**Re:** Legistar #78428, 1609 S. Park St.  
Meeting of August 28, 2023, Agenda Item 18

Plan Commission  
Meeting of August 28, 2023  
Legistar #78428, 1609 S Park

Google Maps; page C201 of the plans.

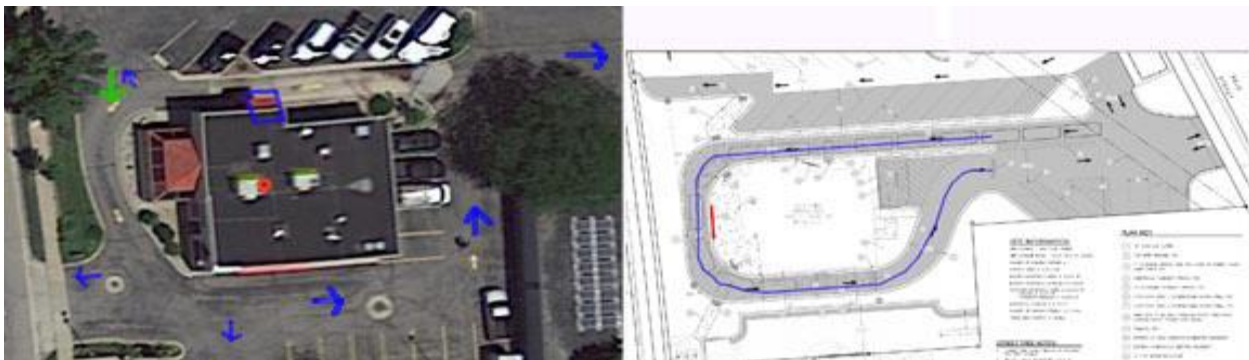
Staff has said the existing "drive" can remain. However, the proposal changes the existing "drive" into a "vehicle access sales and service ... drive." The Starbucks proposal has the drive-thru drive wrapping around three sides of the building, including the S Park (primary street) side of the building. Not only are drive-thru windows prohibited between the primary street-facing façades and the primary street, but the vehicle access sales and service drive is also prohibited between the primary façade and primary street.

With Arby's, customers had a number of means of egress, as reflected above. *After* using the single drive-thru window (blue box), customers could go north to reach the driveway apron on the northern part of the lot, drive around the front of the building to use the S Park exit, drive around the front to use the W Wingra exit, or, drive all the way around the building and use the Beld exit (blue arrows). Vehicles could also access the front drive from the north side of the lot (green arrow).

The Starbucks's site plan reflects a vehicle access sales and service drive that is about 440 feet in length (blue line, image on the right). That vehicle access sales and service drive starts where a vehicle becomes sandwiched between two curbs, continues around the front of the

building and extends to the “do not enter” pavement striping. There are no entrances or exits on this 440 stretch of pavement. Clearly, the use of this pavement is limited to a vehicle access sales and service drive. The existing nonconforming use (a drive in front of the building) would be expanded to a vehicle access sales and service drive, a prohibited use, one that could very well have a line of idling vehicles.

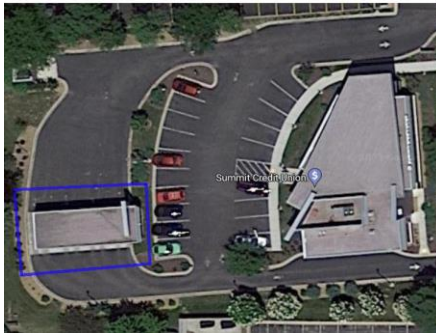
What is not readily visible in the plans is the ordering facility on the north side of the building. It is not reflected in the renderings on pdf page 13 of the revised plans, perhaps because it is not part of the building. However, pdf pages 5-8 (sheets C201, C300, C400, and L100) all show a “Drive Thru Menu Board” and a “Drive Thru Kiosk and Awning” on the north side of the building (see pdf page 5, sheet C201 for the key that explains numbers “16” and “17” on the plans). This ordering facility on the north side of the building does not even have any pretense of being located under the building.

MGO 28.211 defines a “vehicle access sales and service window” as “a facility consisting of a driveway and window, opening, canopy *or other facility used for serving patrons ...*” (emphasis added) Clearly a kiosk, awning and menu sign come within the meaning of “other facility.”

Google Street View, July 2022

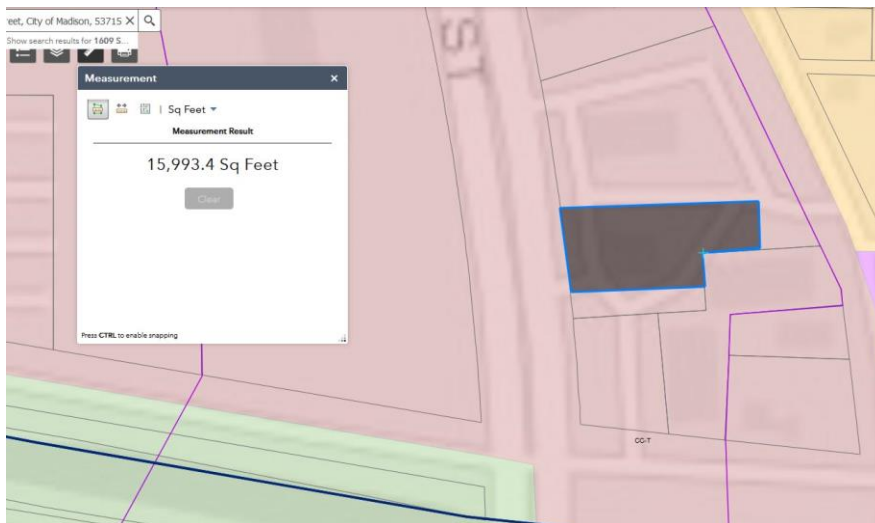
MGO 28.185 defines demolition as "An act or process that removes, pulls down, tears down, razes, deconstructs, or destroys an existing building wall facing a public street..." This section has been applied in the past, see, e.g., Legistar 29724, where an auto dealer remodeled and the front façade was removed and replaced.

- The sunroom-like structure to the left is being demolished.
- The building wall to the right is being demolished. This wall, with its window, is under the main building roof. There is a visible opening at the front and another to the south, making this area into a sort of covered breezeway.

- See pdf page 14, sheet D1.2, "Demo Floor Plan" which refers to "wall" and "screen wall."

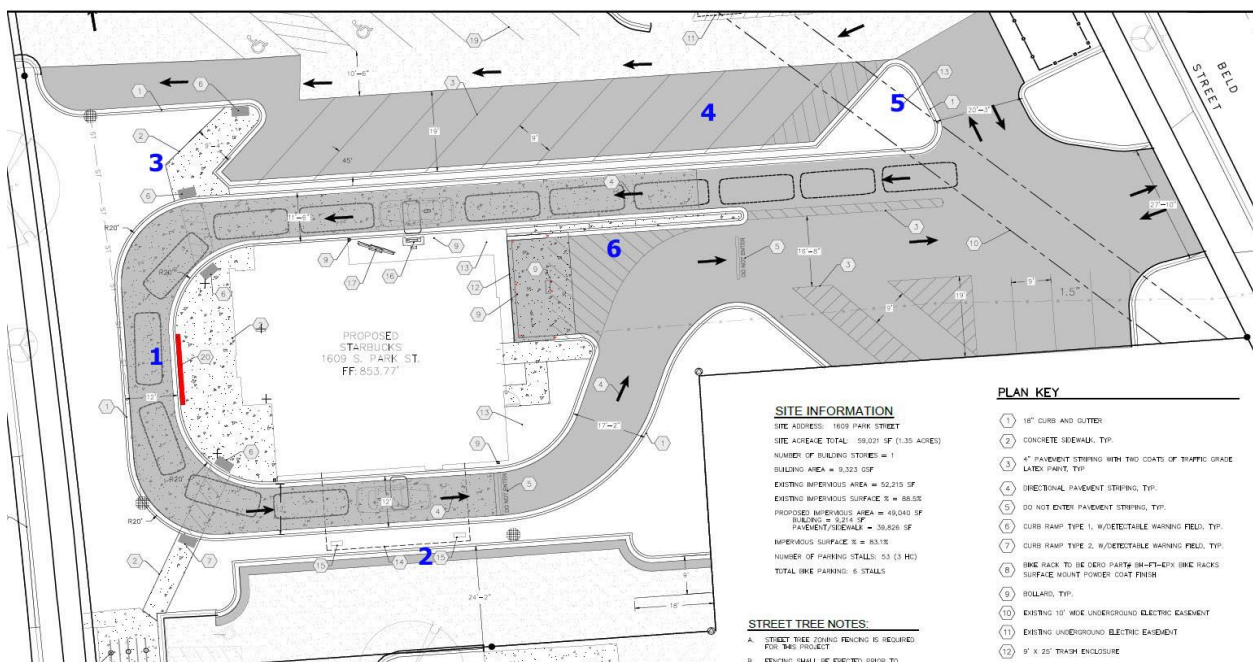
The changes being made to the southern half of the site go beyond these exceptions.

1. The front drive aisle/vehicle access sales and service drive is being flattened and moved closer to the building. The existing drive will overlap with the new drive for only a short stretch – most of the drive is pulled closer, though at the southern end the drive is pushed a bit further from the building.
2. The access through the parking lot to the south is being closed off.
3. The existing drive from the north side of the property is being closed off and replaced with lawn.
4. Three or four new parking spaces are being created.
5. The new grass area will be in an area currently a drive.
6. The lot is being marked with yellow stripes to show it is no longer a drive area.
